FINAL DRAFT RESOURCE CONSERVATION AND RECOVERY FACILITY INVESTIGATION
CNC CHARLESTON SC
3/1/1991
KEMRON ENVIRONMENTAL SERVICES

Response to USEPA and SC DHEC Comments

**RCRA Facility Investigation Workplan (dated March 1991)
Charleston Naval Base
Charleston, South Carolina**

RESPONSES TO EPA
COMMENTS ON
RFI WORK PLAN (Dated March 1991)
FOR

Figure 3-9. Proposed sample locations at SWMU #29.

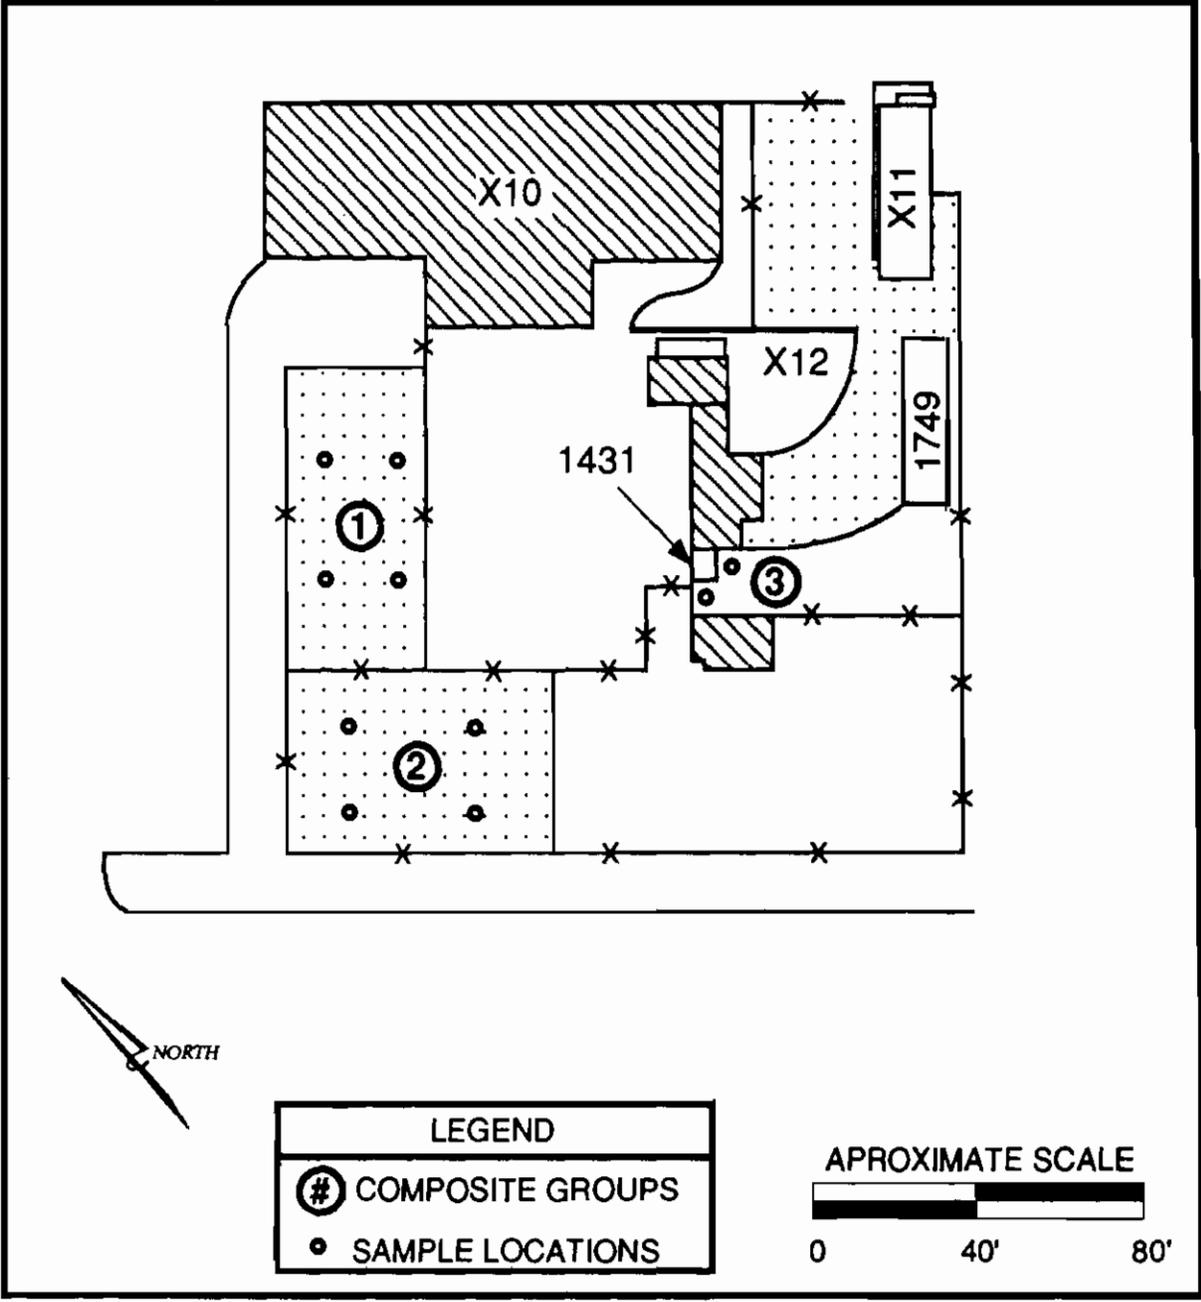
50. Figure 3-9

Response: Figure 3-9 is now Figure 3-11. The boundary of the SWMU is illustrated by a heavier black line. The subtitle "SWMU Boundary" was mistakenly omitted from the final report.
